Road Safety Audit Stage 1

**Bartons Road Access, S278 and S38
Works, Havant**

RSA Report Ref.	Version	Date of Issue
RSA1123	Final	21/01/2026

Designer's Response to the Stage 1 Safety Audit Rev B

NOTES

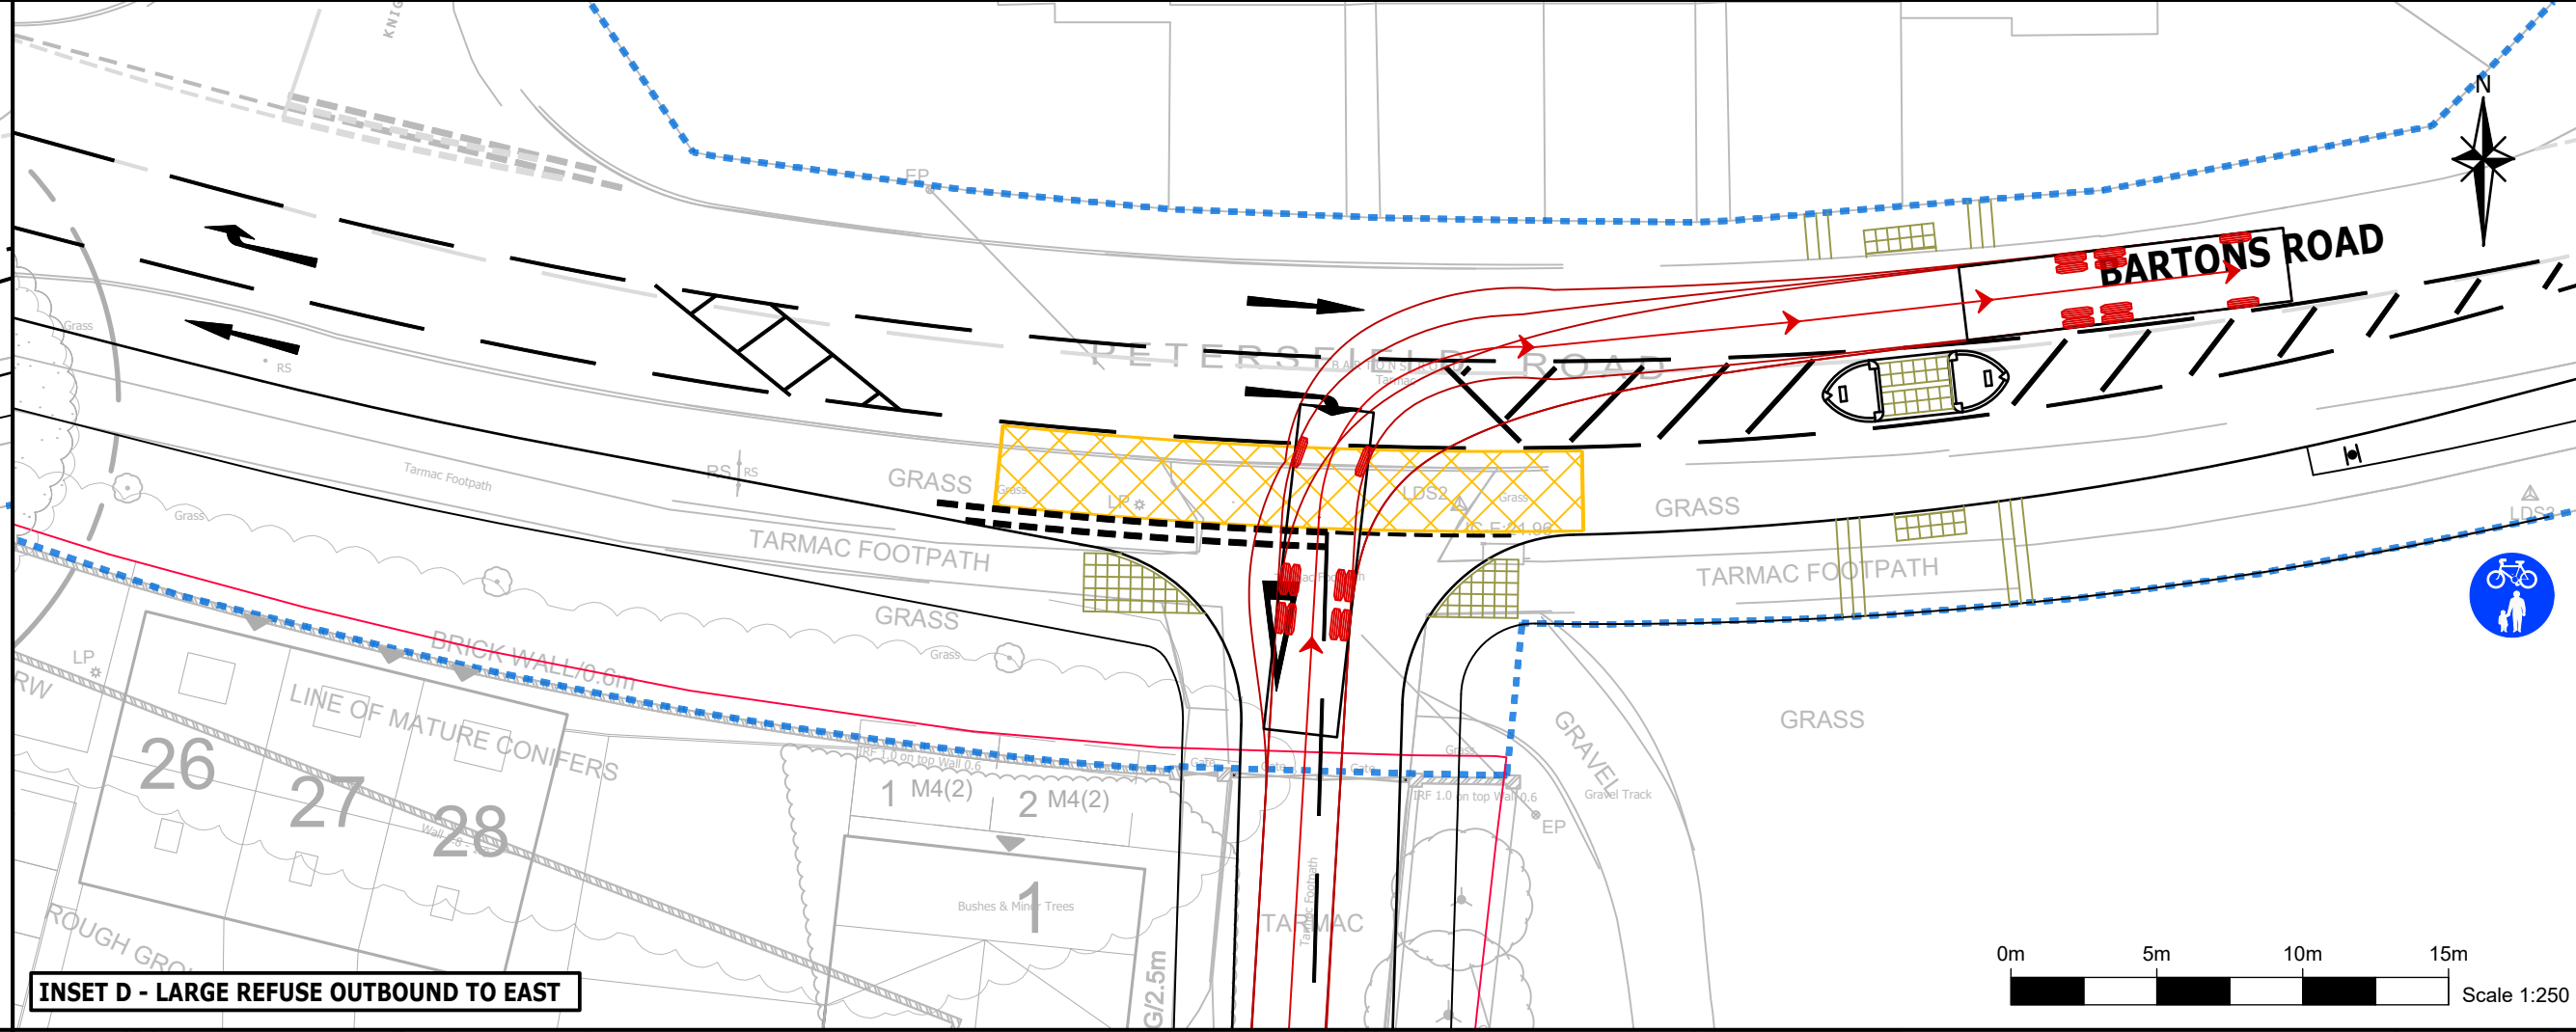
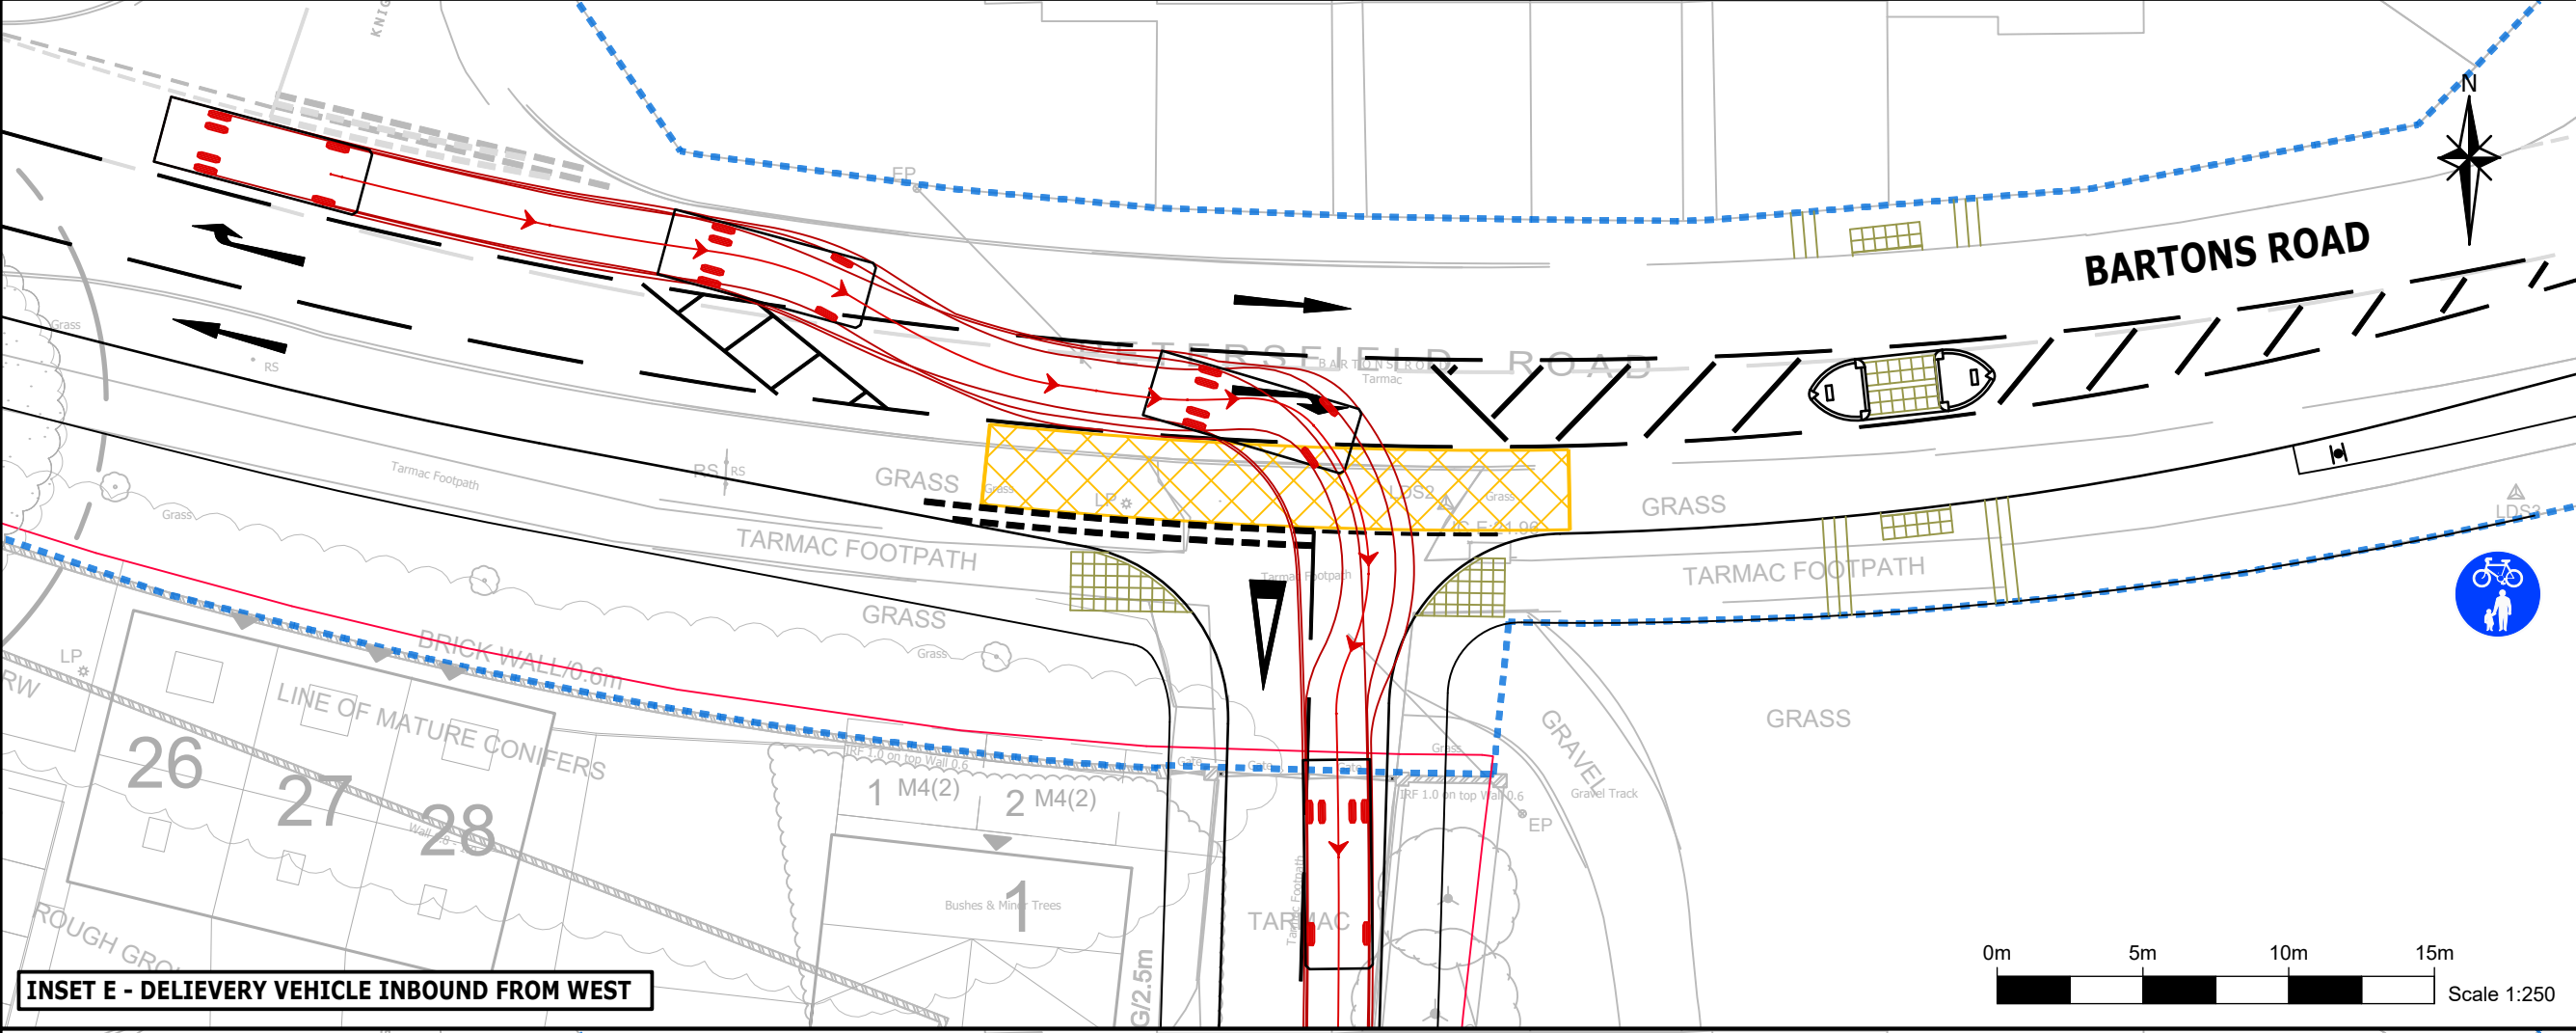
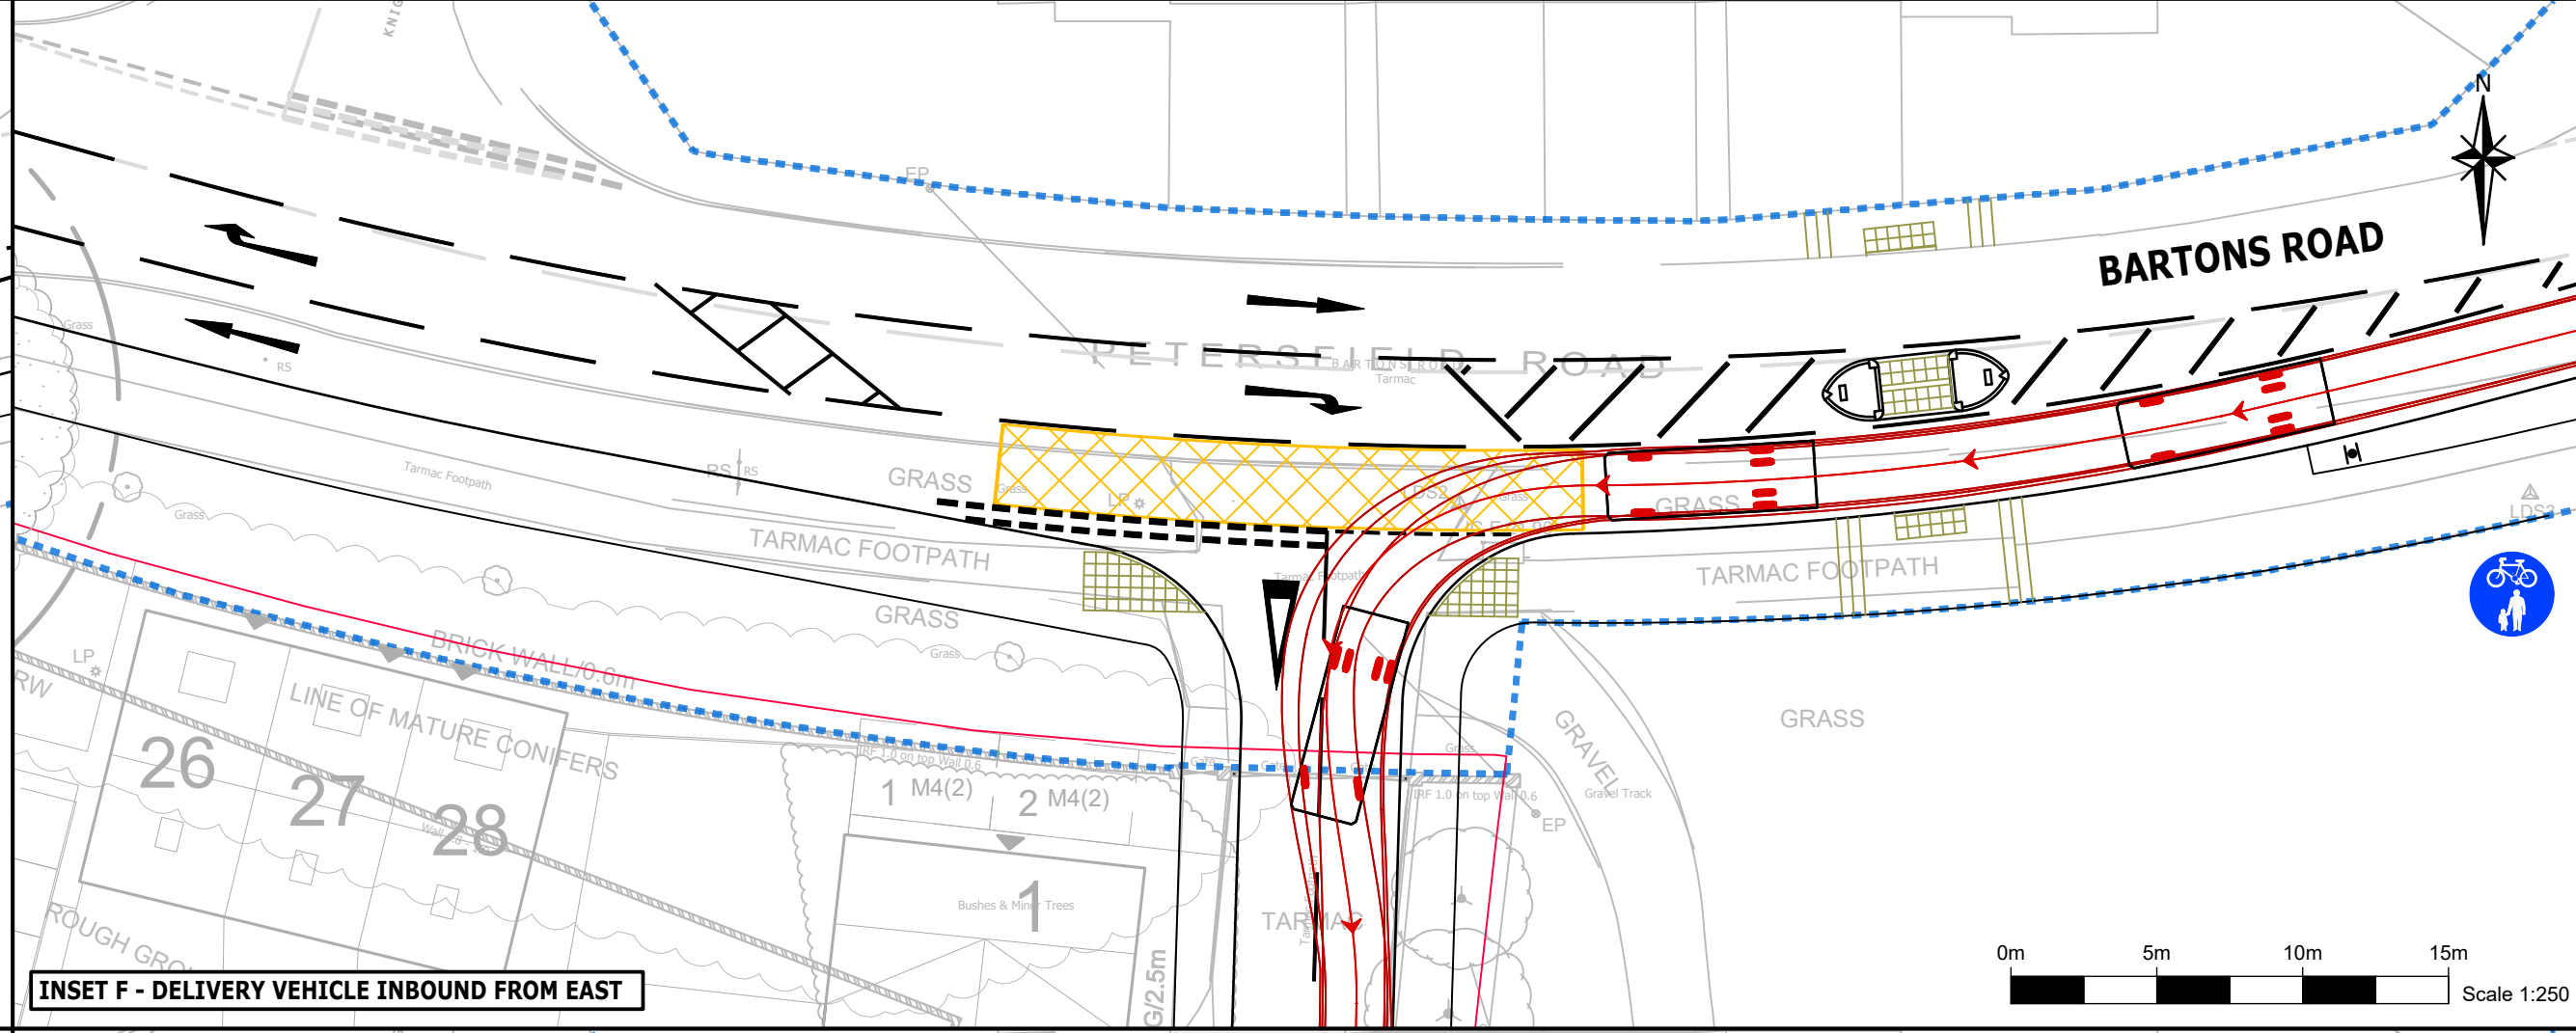
The existing dropped kerbs at this crossing point are not opposite one another (photo 4). If the tactile paving is installed in the location shown on the drawing, without altering the dropped kerbs on the northern side, blind pedestrians crossing from south to north will be guided into the transition and full height kerbs, increasing their risk of trips and falls.

On the north side of Bartons Road the kerbs should be dropped adjacent to the proposed tactile paving and the existing dropped kerbs raised to full height away from the crossing point.

Blind and partially sighted pedestrians alighting from the bus should be reminded that they are walking onto a shared cycle/footway as they pass the gaps within, and to the side of, the bus shelter (photo 5), so that they can orientate themselves on the facility to minimise their risk of collisions with cyclists: blind pedestrians are taught to follow the edge of a shared cycle footway rather than the centre when they are entering a footway.

Corduroy paving should be installed within, and adjacent to, the bus shelter abutting the northern edge of the cycle/footway.

On the northern side of this uncontrolled crossing the tactile paving will coincide with the dropped kerbs for the uncontrolled crossing of Forestside Avenue. Pedestrians crossing Forestside Avenue may mistakenly use the new tactile paving for the Bartons Road crossing and encounter a full height kerb on the eastern side of Forestside Avenue, increasing their risk of trips and falls.

The tactile paving for the proposed crossing of Bartons Road should not coincide with the dropped kerbs for the crossing of Forestside Avenue. If necessary, the uncontrolled crossing of Forestside Avenue should be relocated slightly further away from Bartons Road, with new dropped kerbs and tactile paving.

An existing lamp column, currently in the verge (photo 6), is likely to be within the shared cycle/footway increasing the risk of cyclists colliding with it.

The lamp column should be relocated away from the cycle/footway i.e. near the carriageway of Bartons Road.

Blind and partially sighted pedestrians entering the cycle/footway from the church forecourt need to be reminded that they are entering a shared facility so that they can orientate themselves on the facility to minimise their risk of collisions with cyclists.

Corduroy paving should be installed at the edge of the cycle/footway abutting the top of the flight of steps up from the church forecourt.

There is a risk that users of the proposed refuge island on Bartons Road may step directly onto the shared cycle/footway without warning. Clear warnings are required for blind and partially sighted pedestrians to indicate entry into a shared facility, enabling safe orientation and reducing collision risk with cyclists.

Corduroy paving should be installed either side of the footway close to the pedestrian refuge island.

3.9	<p>Problem</p> <p>Location: I – The uncontrolled pedestrian crossing of Barton Road, just west of Witchampton Close (Dwg. 24-097/017).</p> <p>Summary:</p> <p>Risk of pedestrian trips and falls on the transition kerbs and full height kerbs.</p> <p>The existing dropped kerbs at this crossing point are not opposite one another (photo 4). If the tactile paving is installed in the location shown on the drawing, without altering the dropped kerbs on the northern side, blind pedestrians crossing from south to north will be guided into the transition and full height kerbs, increasing their risk of trips and falls.</p>	<p>Recommendation:</p> <p>On the north side of Bartons Road the kerbs should be dropped adjacent to the proposed tactile paving and the existing dropped kerbs raised to full height away from the crossing point.</p>	<p>Agree:</p> <p>Dropped kerb to be provided adjacent to the proposed tactile paving and the existing dropped kerbs raised to full height away from the crossing point, as illustrated in Drawing 24-097/017 Rev B.</p>

3.10	<p>Problem</p> <p>Location: J – The westbound bus stop and shelter (Dwg. 24-097/017).</p> <p>Summary:</p> <p>Risk of collision between blind pedestrians and cyclists on the shared facility.</p>	<p>Recommendation:</p> <p>Corduroy paving should be installed within, and adjacent to the bus shelter abutting the northern edge of the cycle/footway.</p>	<p>Agree:</p> <p>Corduroy paving to be provided within, and adjacent to the bus shelter abutting the northern edge of the cycle/footway, as illustrated in Drawing 24-097/017 Rev B.</p>

3.11	<p>Problem</p> <p>Location: K – Uncontrolled pedestrian crossing just west of Forestside Avenue (Dwg. 24-097/017).</p> <p>Summary:</p> <p>Risk of pedestrian trips and falls.</p> <p>On the northern side of this uncontrolled crossing the tactile paving will coincide with the dropped kerbs for the uncontrolled crossing of Forestside Avenue. Pedestrians crossing Forestside Avenue may mistakenly use the new tactile paving for the Bartons Road crossing and encounter a full height kerb on the eastern side of Forestside Avenue, increasing their risk of trips and falls.</p>	<p>Recommendation:</p> <p>The tactile paving for the proposed crossing of Bartons Road should not coincide with the dropped kerbs for the crossing of Forestside Avenue. If necessary, the uncontrolled crossing of Forestside Avenue should be relocated slightly further away from Bartons Road, with new dropped kerbs and tactile paving.</p>	<p>Agree:</p> <p>New dropped kerbs and tactile paving to be provided to relocate the existing uncontrolled crossing of Forestside Avenue, as illustrated in Drawing 24-097/017 Rev B.</p>

3.12	<p>Problem</p> <p>Location: L – Southern side of Bartons Road opposite Forestside Avenue (Dwg. 24-097/017).</p> <p>Summary:</p>	<p>Recommendation:</p> <p>The lamp column should be relocated away from the cycle/footway i.e. near the carriageway of Bartons Road.</p>	<p>Agree:</p> <p>Proposed footway to have localised narrowing if required to prevent risk of collision with existing lamp column as illustrated in Drawing 24-097/017 Rev B.</p>

3.13	<p>Problem</p> <p>Location: M – Southern side of Bartons Road at the steps up from the church (Dwg. 24-097/017).</p> <p>Summary:</p> <p>Risk of collisions between blind pedestrians and cyclists on the shared facility.</p> <p>Blind and partially sighted pedestrians entering the cycle/footway from the church forecourt need to be reminded that they are entering a shared facility so that they can orientate themselves on the facility to minimise their risk of collisions with cyclists.</p>	<p>Recommendation:</p> <p>Corduroy paving should be installed at the edge of the cycle/footway abutting the top of the flight of steps up from the church forecourt.</p>	<p>Agree:</p> <p>Corduroy paving to be provided, as shown in Drawing 24-097/017 Rev B.</p>

3.14	<p>Problem</p> <p>Location: N – Southern side of Bartons Road at the proposed pedestrian refuge island (Dwg. 24-097/017).</p> <p>Summary:</p> <p>Risk of collisions between blind pedestrians and cyclists on the shared facility.</p>	<p>Recommendation:</p> <p>Corduroy paving should be installed either side of the footway close to the pedestrian refuge island.</p>	<p>Agree:</p> <p>Corduroy paving to be provided, as shown in Drawing 24-097/017 Rev B.</p>
